ACCELERATED DISTRIBUTION DEMONSTRATION SYSTEM

SUBJECT: Responds to NRC 880127 telcon requesting addl. info re ATWS mitigation sys actuation circuitry.

Donald C. Cook Nuclear Plant Units 1 and 2
Docket Nos. 50-315 and 50-316
License Nos. DPR-58 and DPR-74
GENERIC LETTER 83-28 ANTICIPATED TRANSIENT
WITHOUT SCRAM (ATWS) MITIGATION SYSTEMS
ACTUATION CIRCUITRY (AMSAC) ADDITIONAL INFORMATION

AMSAC LOGIC DIAGRAM Rev. 1

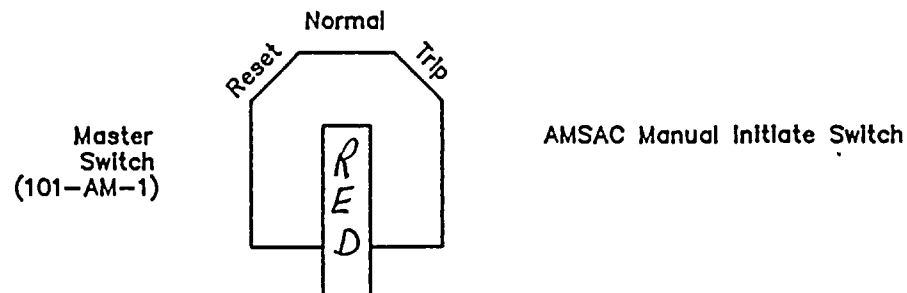
d) Where is the "AMSAC Test Successful" light located?

In addition, during the January 27, 1988 teleconference, your staff requested that we describe the latest annunciation scheme for AMSAC and provide a copy of the logic diagram which indicates from where the signals are coming.

Attachment No. 1 contains the revised AMSAC logic diagram. The revisions are described below:

1. When AMSAC is in the bypass/test mode, the AMSAC initiate relays are disabled.
2. When AMSAC is in the bypass/test mode, a simulated signal indicating above 40% power is used to test AMSAC logic.

The above mentioned revisions to the logic diagram are identified by dotted lines.

Suggested AMSAC Trip-Reset Control Switch Location on DTU Panel

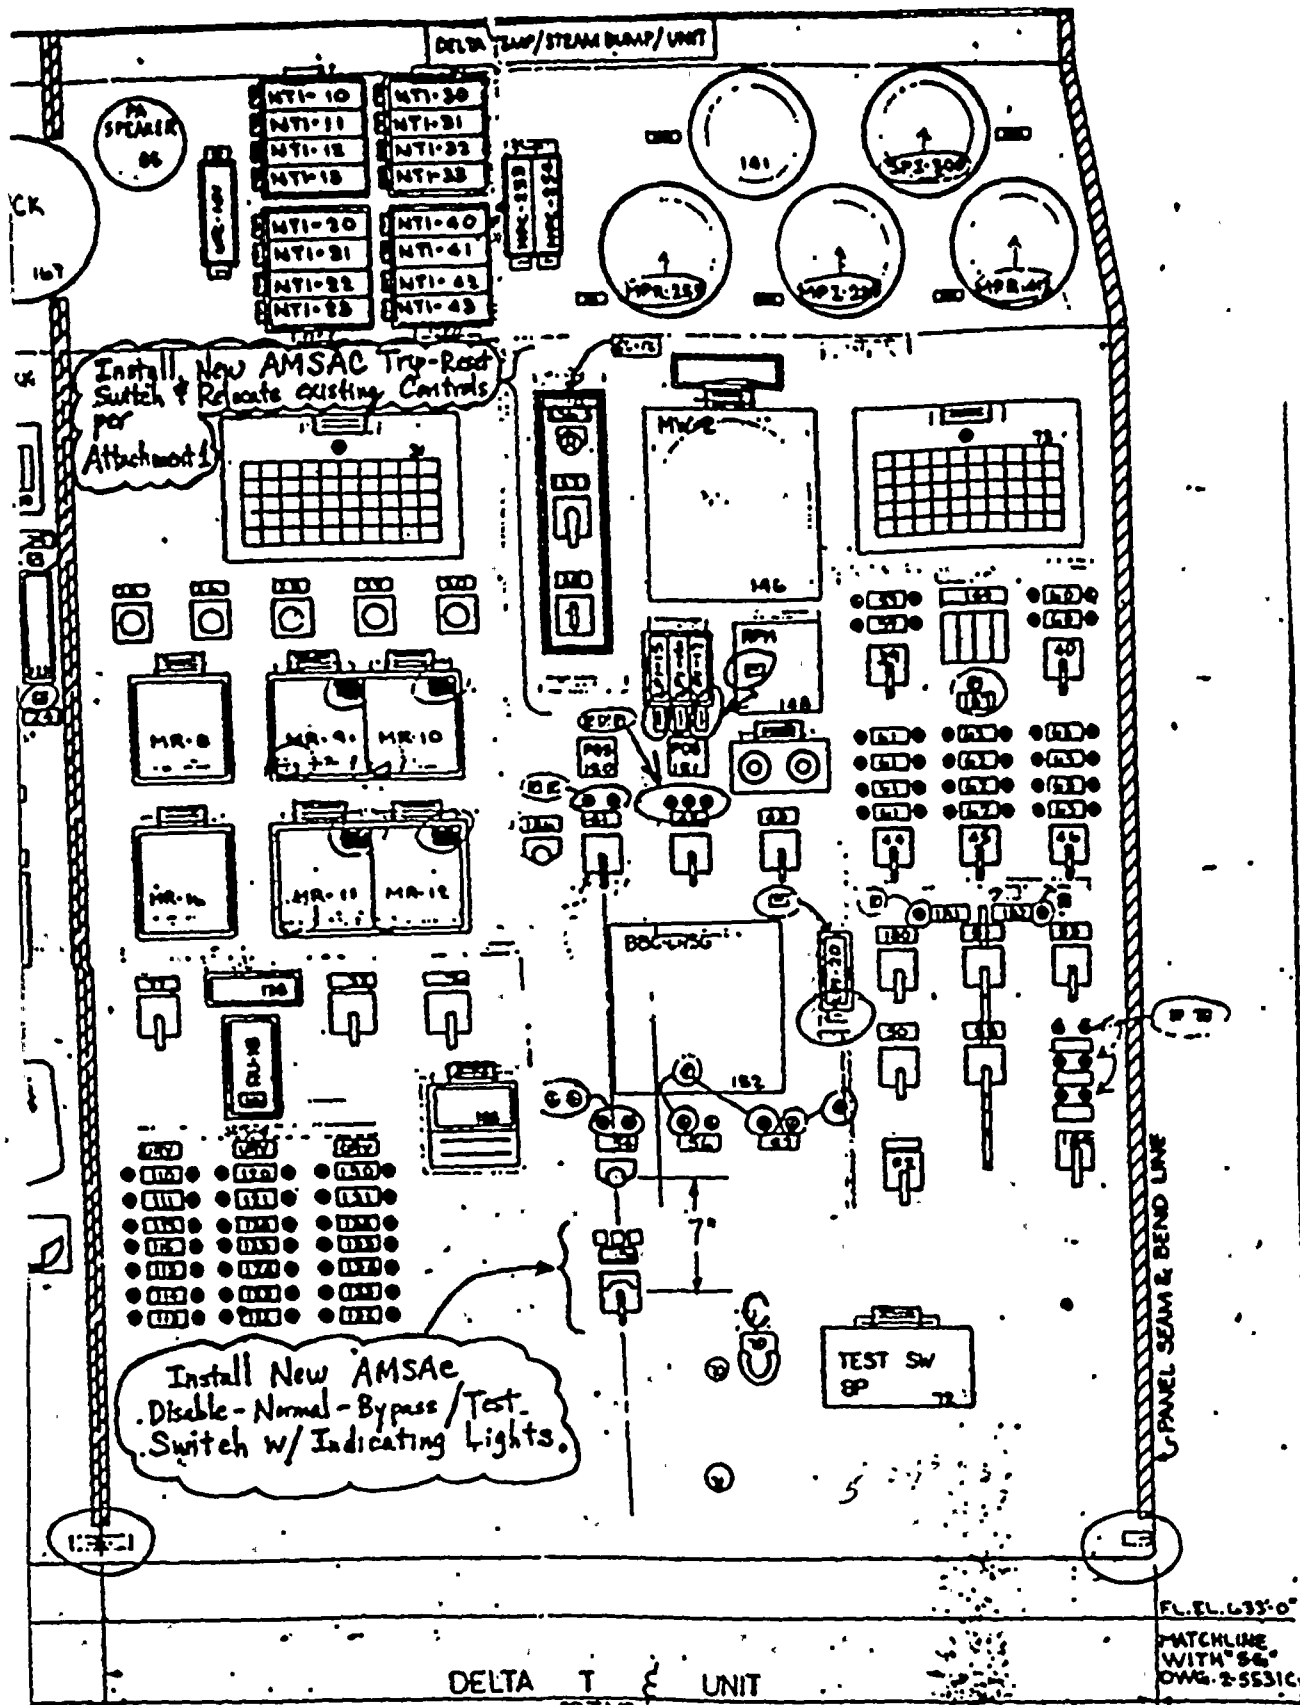
Install New
AMSAC
Trip-Reset SW

Relocate Main Turbine
Vacuum Breaker Trip
Solenoid Trip
Turbine Reset
Controls

Note: Spacings between
Controls less than stand-
ard, but satisfactory since
no indicating lamps with
switches and space re-
strictions are acute

Have EGS verify above
dimensions physically
possible
